# TOWN OF DIGHTON PLANNING BOARD

## **\*REVISED AGENDA**

- b. **PUBLIC HEARING:**
    - i. Trinity Solar, LLC, 1205 Briggs Street (Map 8, Lot 90), Special Permit and Site Plan Review
    - ii. Antone P Roderick, 128 Hart Street (Map 20, Lot 100-1), Definitive Subdivision Application

In accordance with your request, Weston & Sampson is pleased to provide this second review of the above-referenced application. The purpose of this letter report is to provide comments on the proposed project as it currently relates to regulatory compliance with the applicable sections of the Zoning Bylaws of the Town of Dighton Massachusetts (June 9, 2025), the Town of Dighton Subdivision Rules and Regulations (August 19, 2020) and the Massachusetts Stormwater Handbook as promulgated under 310 CMR 10.00. We conducted our first review of this application and provided comments in a letter dated April 27, 2026. This second review has been conducted based on additional materials provided to us on May 19, 2026, including revised plans and supporting by Zenith Consulting Engineers, LLC on behalf of Antone P. Roderick the "Owner." According to the "Letter to the Planning Board" Definitive Subdivision Appli

From Basin Outlet Pipe

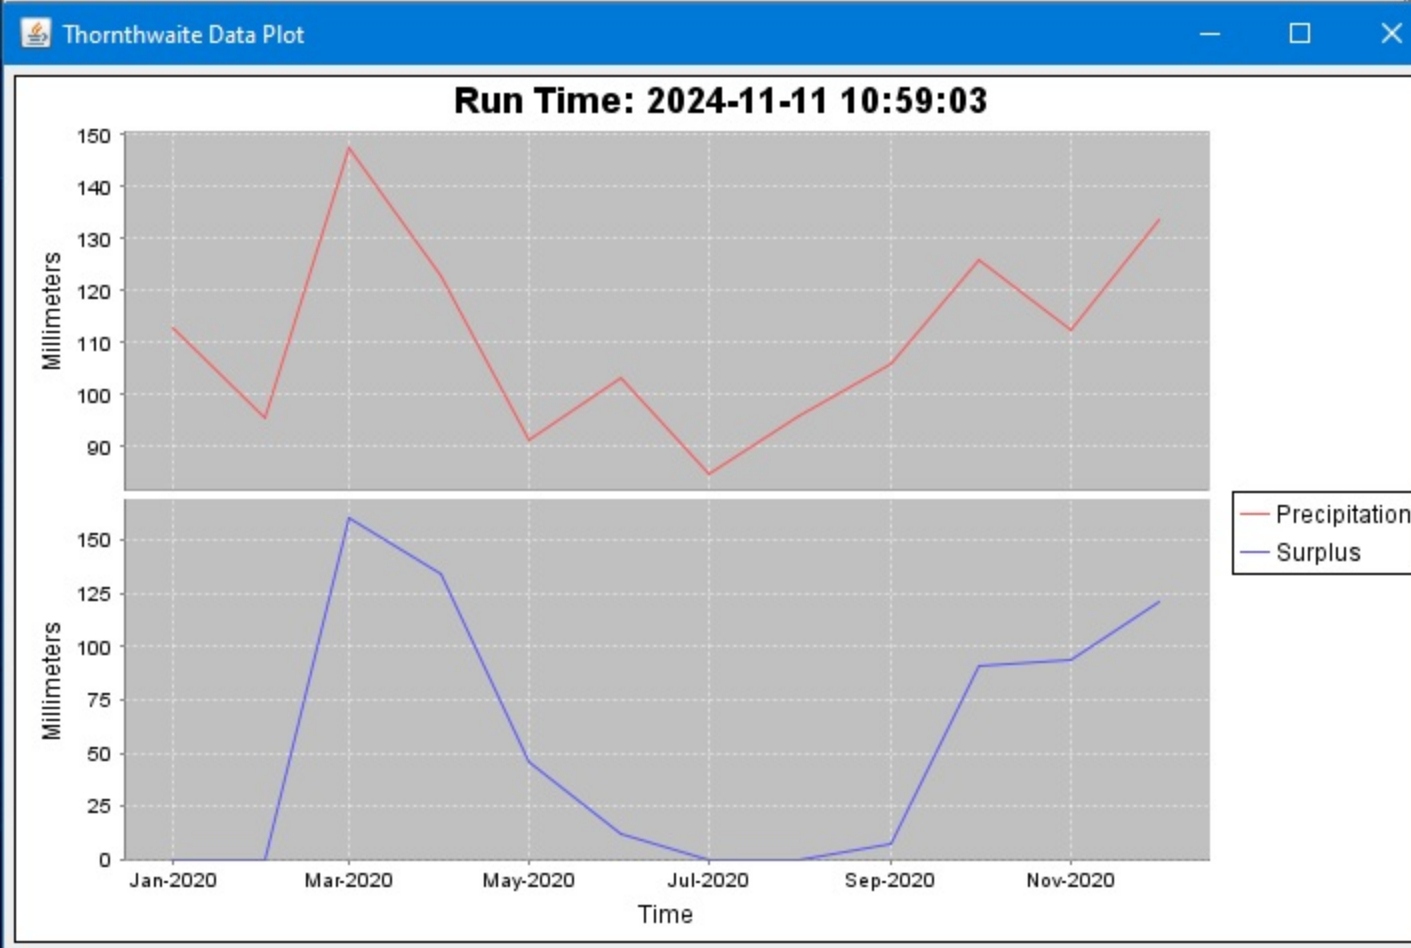
WSE COMMENT: The engineer has designed a basin that will discharge stormwater during the 100-year storm event using an outlet pipe discharging to a stone splash pool which also functions as a level spreader. Calculations were not found in the submission showing sizing for the stone in the splash pool and spillway, or the velocity of the overflow at the level spreader to show that velocities leaving the level spreader do not create scour. We recommend that the engineer address this.

**WSE COMMENT:** The engineer indicated that the discharge velocity from the basin outlet pipe is approximately 4.08 fps, as documented in the revised HydroCAD calculations. This velocity falls within the generally accepted

range of 3 to 5 fps to minimize the potential for scour. Additionally, the engineer replaced the previously proposed splash pool with a riprap apron and provided supporting riprap sizing calculations in the revised drainage report. This comment has been addressed.
